IMPROVEMENT PERMIT for a RESIDENTIAL ON-SITE WASTEWATER TREATMENT & DISPOSAL SYSTEM

GWS Septic System Design Review

RE: Request for an Improvement Permit for Lot 12 off of Sample Road.
MCHD File #6750B

SEPTIC SYSTEM DESIGN REVIEW WORKSHEET

Sketch of Soil Evaluation Locations

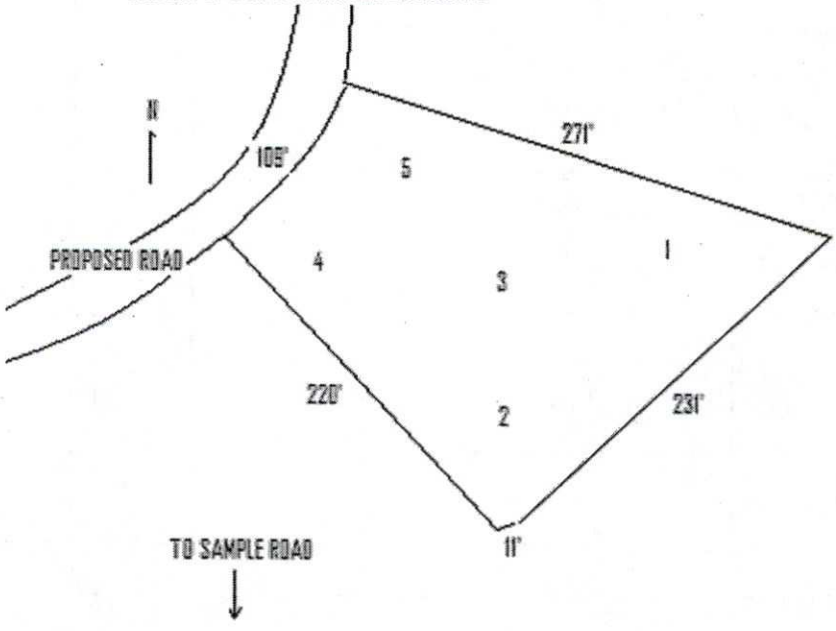
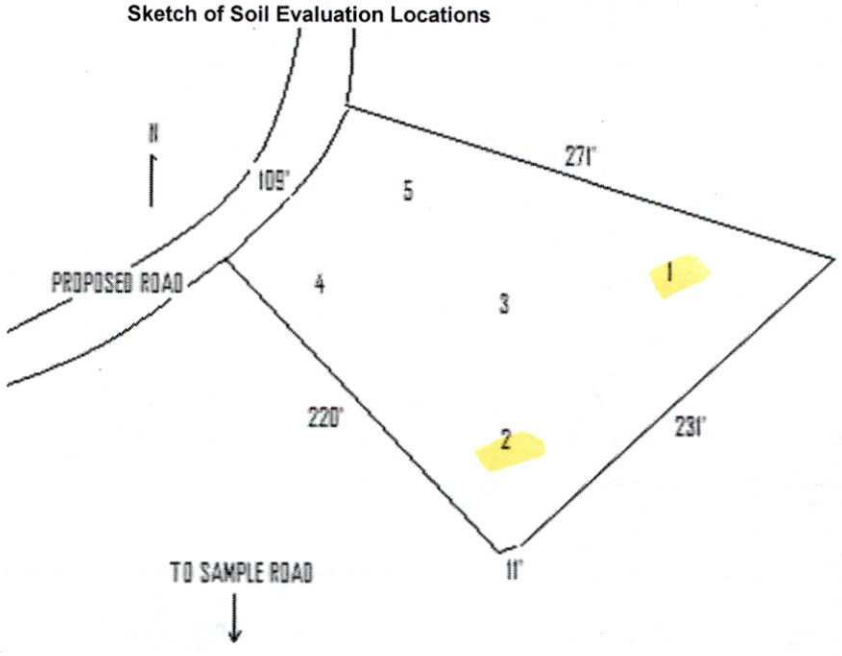
1. Need to get revised application indicating 5 bedroom house (600 GPD).
2. Need to revise soil report to show evaluation for a 5 bedroom house (600 GPD).
